SAFETY RECALL NOTICE

Re: Can-Am® Spyder® Roadster – Tandem Master Cylinder Manifold Inlet - Fire Hazard

Subject: **Can-Am™ Roadster - Tandem Master
Cylinder Manifold Inlet- Fire Hazard**

No. **2013-8**

PROPER AND IMPROPER INSTALLATION

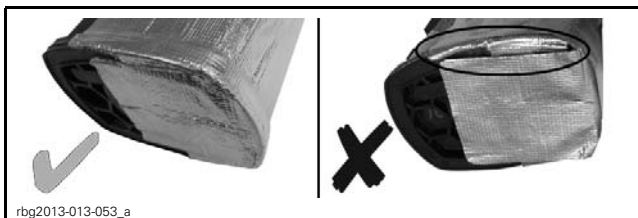
Install the reflective heat shield [P3] on the canister.

Use the following illustrations to position the reflective heat shield properly on the canister.

NOTICE Corner junctions must be completely covered by the reflective heat shield.

TYPICAL - VIEW FROM RIGHT SIDE

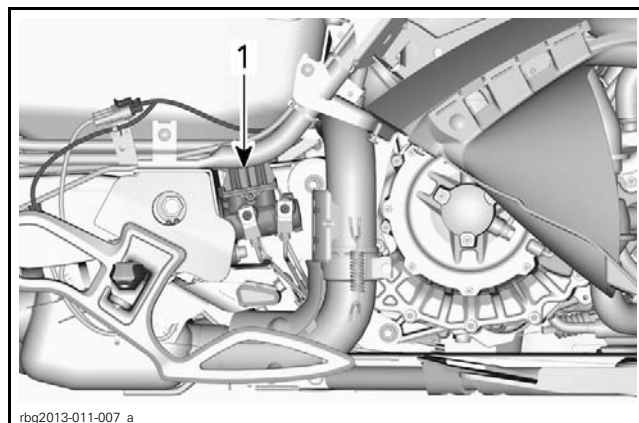
With the tandem master cylinder still installed on the vehicle, visually inspect the tandem master cylinder manifold inlet for signs of deformation.

USE ILLUSTRATIONS AT THE END OF THIS BULLETIN TO DETERMINE IF THE DAMAGES TO THE COMPONENT ARE ACCEPTABLE OR NOT.

SITUATION	TO DO
ACCEPTABLE ✓	Install all reflective heat shields and the heat deflector as per the procedure described in this bulletin.
NON-ACCEPTABLE ✗	Replace the tandem master cylinder, refer to <i>SERVICE BULLETIN 2013-9</i> for the latest procedure. Install heat deflector and all reflective heat shields.

rbg2013-011-500_a

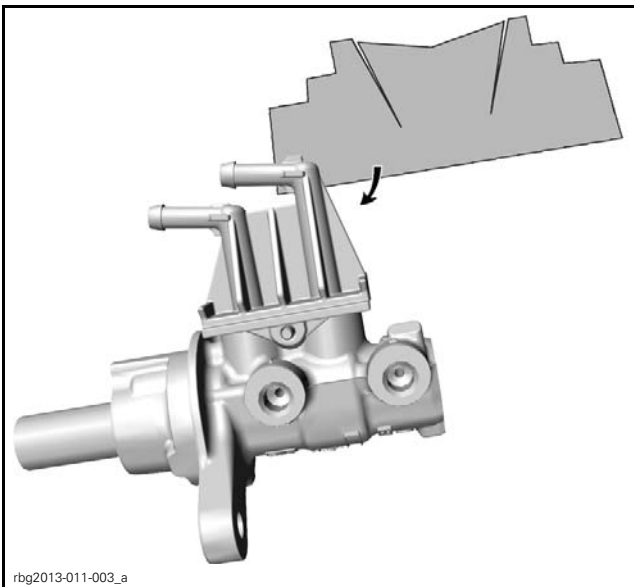
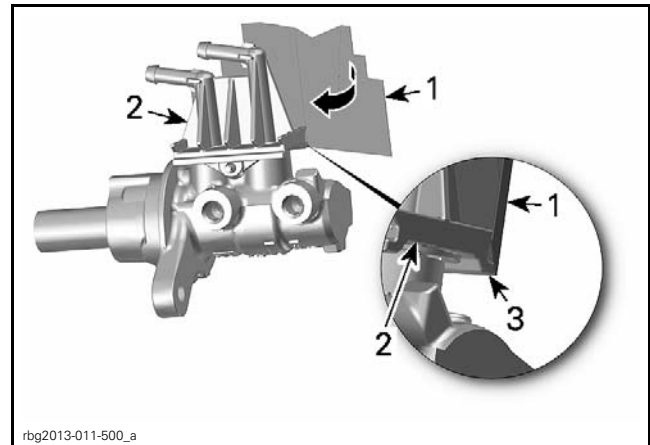
4. Remove the rest of the protective backing. Slide the reflective heat shield between the frame support and the tandem master cylinder manifold inlet aligning the lower edges together.

NOTICE Make sure lower edges of heat shield and manifold inlet are properly aligned.

PROPER AND IMPROPER INSTALLATION

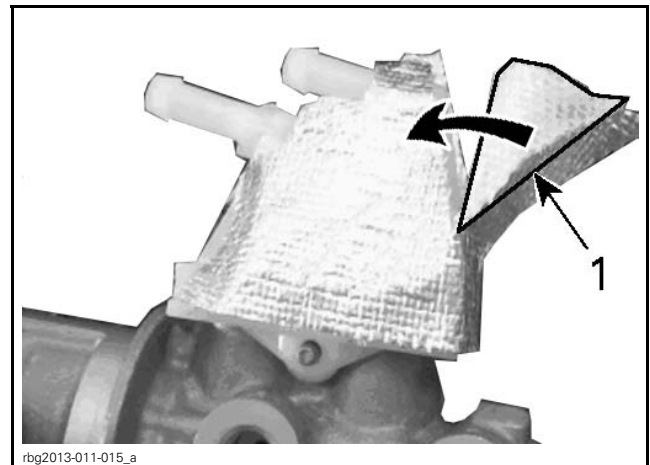
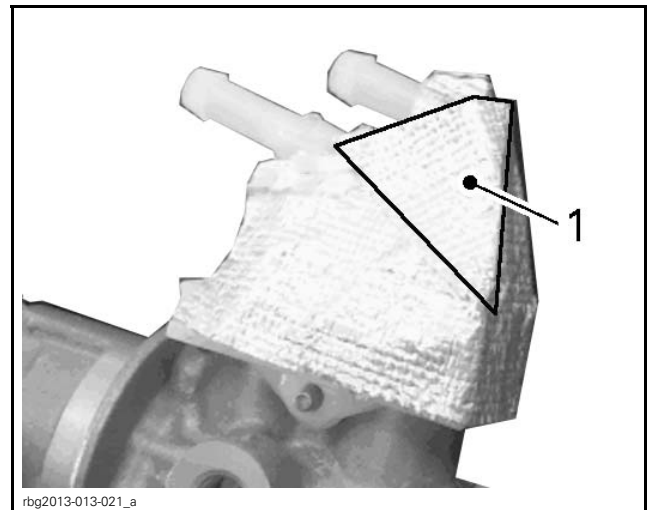
5. Fold the two tabs on tandem master cylinder manifold inlet to finish the installation.

1. Unfolded tabs

1. Folded tabs

VIEW BEHIND TANDEM MASTER CYLINDER

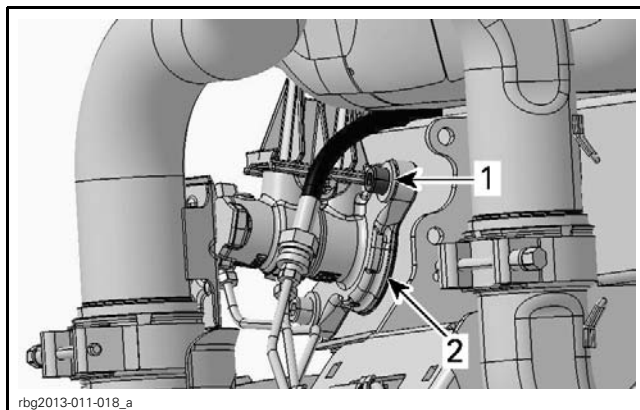
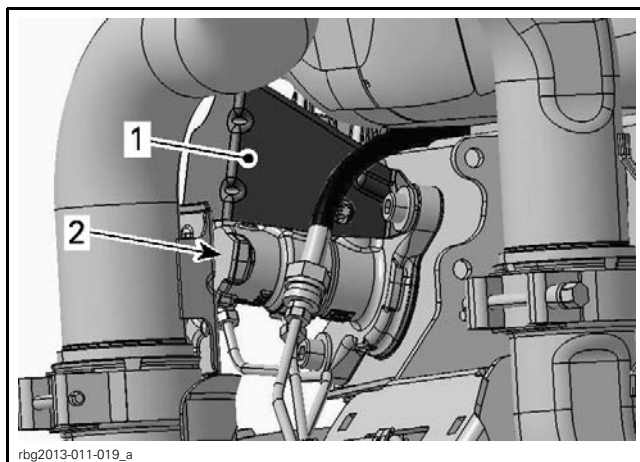
7. Insert the heat deflector [P1]; make sure the tandem master cylinder manifold inlet retaining pin is centered with the hole.

1. Installed heat deflector
2. Tandem master cylinder

VIEW FROM RIGHT SIDE

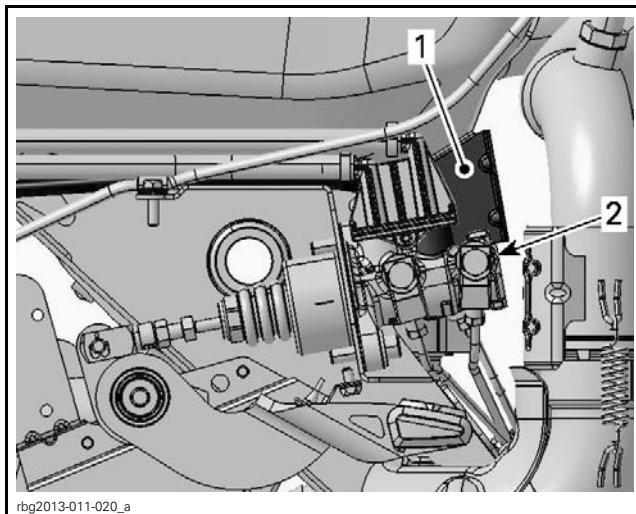
8. Secure tandem master cylinder using the new M8 X 30 hexagonal flange screw [P5].

TIGHTENING TORQUE

M8 X 30 hexagonal
flange screw [P5]

24.5 N•m ± 3.5 N•m
(18 lbf•ft ± 3 lbf•ft)

1. Heat deflector in place
2. Tandem master cylinder

Parking Brake Cable

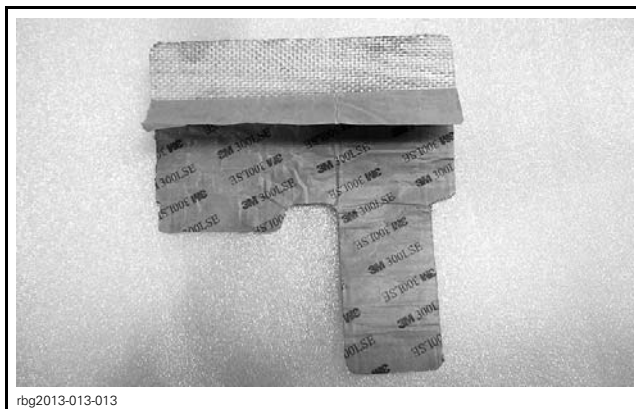
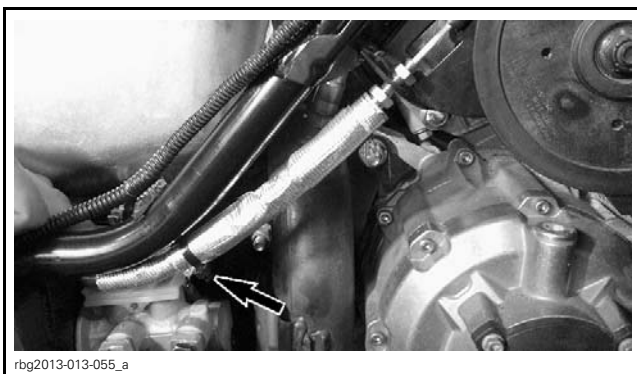
1. Clean the parking brake cable shield with BRP HEAVY DUTY CLEANER (P/N 293 110 001). Let it dry thoroughly.
2. Peel off approximately 25.4 mm (1 in) of the back paper of the reflective heat shield [P4].

3. Start the installation by applying as shown and roll the heat shield around the brake cable as tight as you can.

NOTICE Make sure the heat shield edge leans against the parking brake cable nut.

4. To prevent the unsticking of the heat shield, install a locking tie [P8] at the bottom end of the heat shield.
